Detailed discussion of the VDA position on the proposal for draft amendments to UN-ECE R94

Informal Group "List of Issues"

Time of max. intrusion

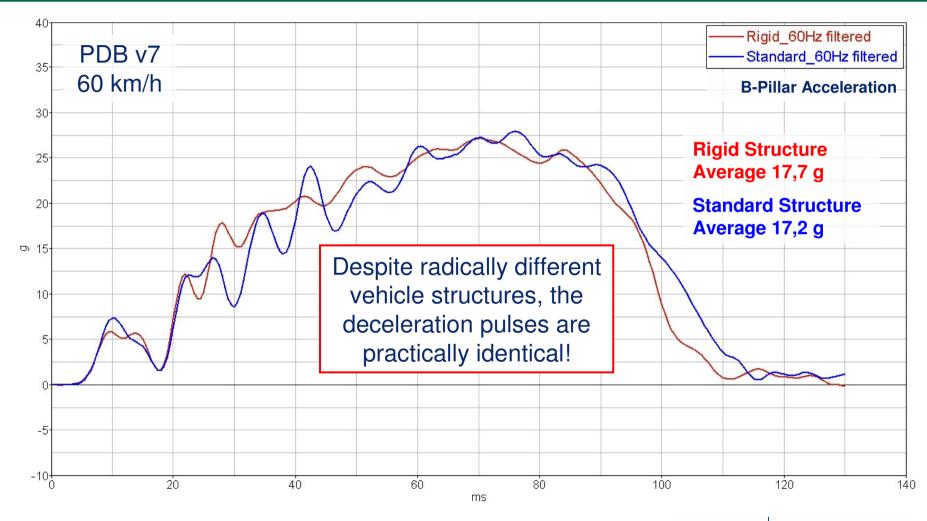
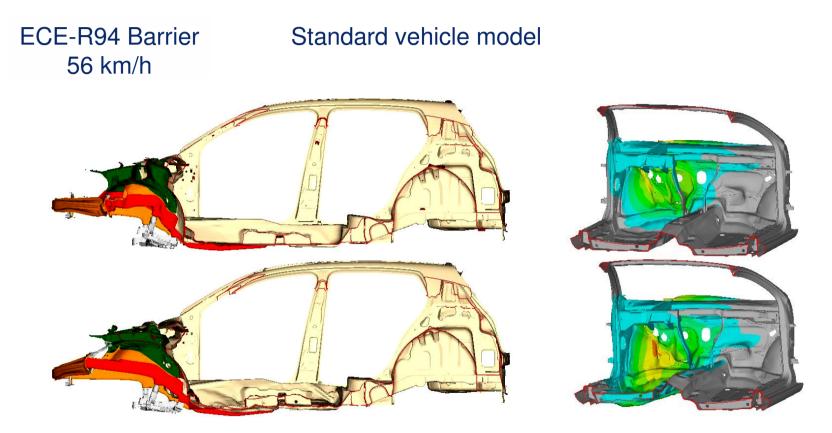
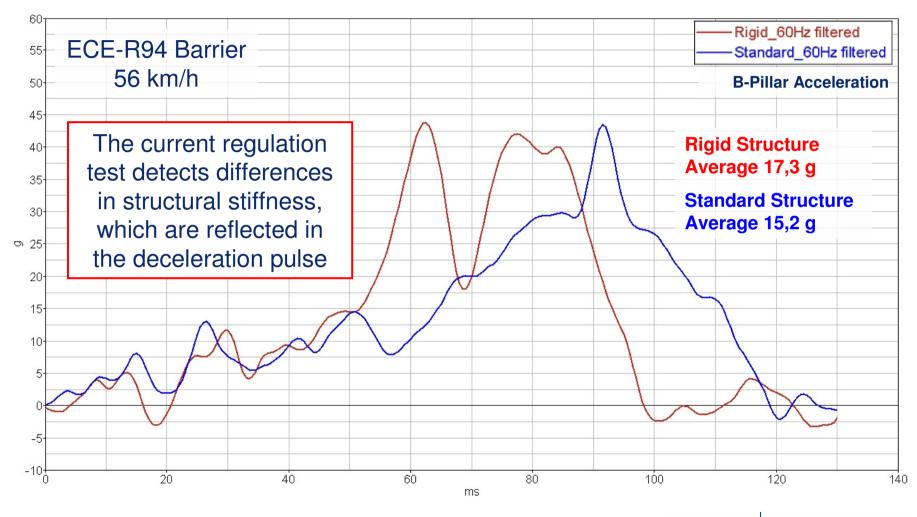
- The PDB test procedure does not punish aggressively stiff structures:
 - The barrier deforms to compensate for a lack of deformation travel in the vehicle front end
 - Compartment intrusions may be reduced
- The compartment accelerations that occur in a PDB test are based on the barrier stiffness, rather than the real stiffness of the vehicle front-end
- The ECE-R94 barrier punishes aggressively stiff structures because the barrier bottoms out and the vehicle must deform
- The compartment accelerations that occur with the ECE-R94 barrier reflect the design of the vehicle front-end and are more severe for the stiffened structure

Misuse of the PDB: Daimler simulations

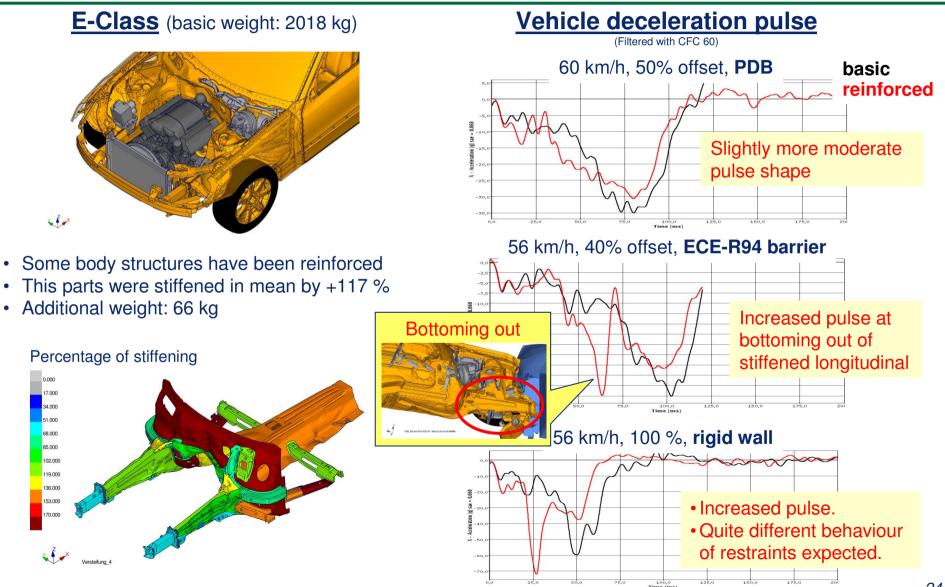
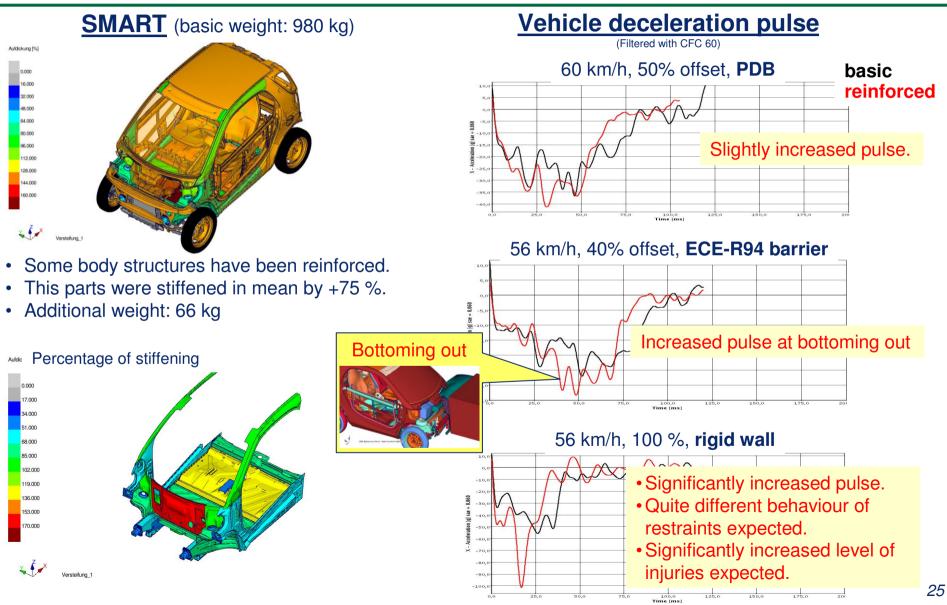
- The vehicle stiffness could be increased without significant change of crash severity assessed by the PDB test procedure.
- Even an opposite effect could be detected in the E-Class.
- The same reinforced vehicle exhibits an increased crash severity in the current ECE-R94 test and rigid wall test.
- Especially in the rigid wall test such a reinforced vehicle exhibits an insufficient safety level.

Effects of front-end stiffness in vehicle to barrier tests:

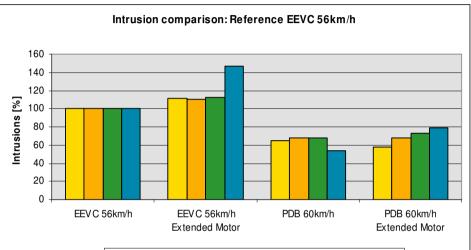
<u>Deformation in passenger compartment</u> In the current ECE-R94 barrier a stiffer front-end causes more deformation in the passenger compartment in comparison to the PDB-barrier

Crash Pulse

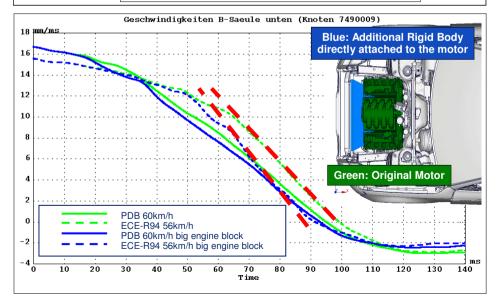
PDB: Engine block leads to small effect ECE-R94: Bigger engine block causes higher crash pulse
